## PLAN COMMISSION

**BLOOMINGTON PLAN COMMISSION****STAFF REPORT – Second Hearing****Location:** 723 W. 1<sup>st</sup> Street, 709 W. 1<sup>st</sup> Street, 607 W. 1<sup>st</sup> Street**CASE #:** ZO2025-12-0018**DATE:** February 12, 2026**PETITIONER:** Bloomington Redevelopment Commission  
401 N. Morton Street, Suite 130, Bloomington, IN**CONSULTANT:** Alli Thurmond (Range Co/Flintlock)  
512 N. Mission Blvd, Fayetteville, AR**REQUEST:** The petitioner is requesting to rezone approximately 6.3 acres to Planned Unit Development and a request for approval of a District Ordinance and Preliminary Plan.**BACKGROUND:****Area:** 6.3 acres

### Hopewell South Planned Unit Development (PUD)

# PEDESTRIAN + STREET NETWORK

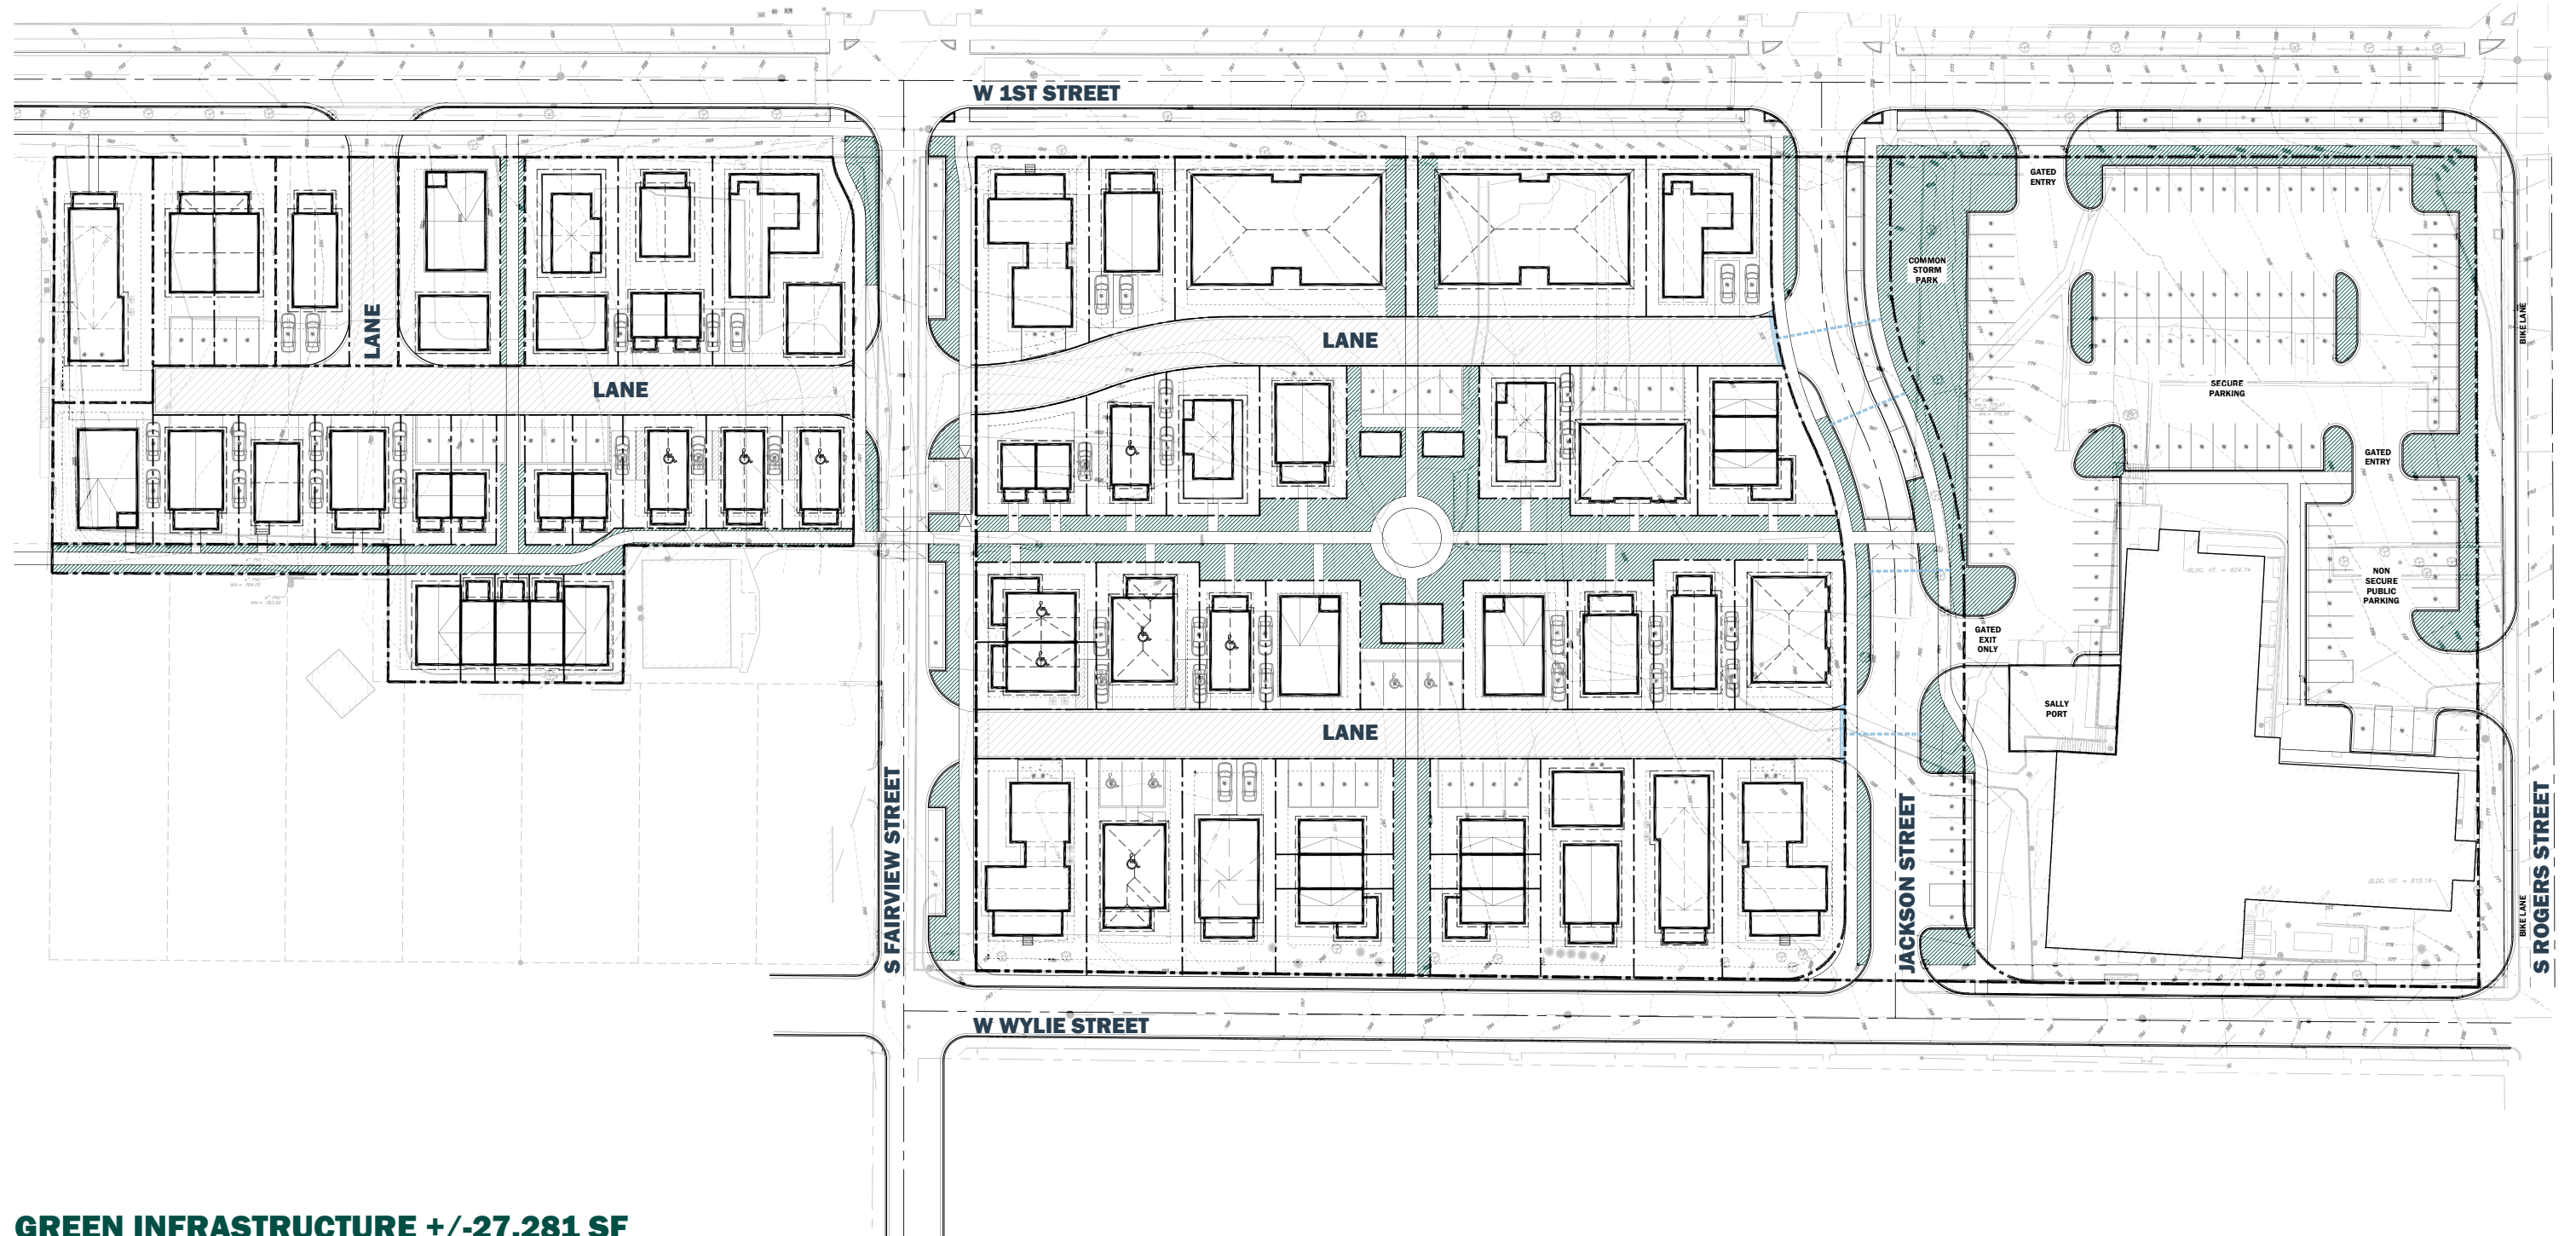
**Multi-use paths are not indicated on the preliminary plan and must be noted is proposed.**

**Pedestrian and Bicycle Circulation:** Internal sidewalks are shown throughout the development connecting to the proposed interior open space and along proposed streets. The Fire Department has expressed a concern regarding access to units that do not have direct access to a public street. Access to all lots must meet Emergency Service's requirements. **The Preliminary Plan needs to specify the width of the interior sidewalks that are not included in the public street cross sections. If multi-use paths are proposed within the PUD, those need to be indicated on the Preliminary Plan.**

As mentioned, with the possibility of lots being created that only front on sidewalks, those lots may be desired to have sidewalk access that is wider than 5' to provide greater accessibility.
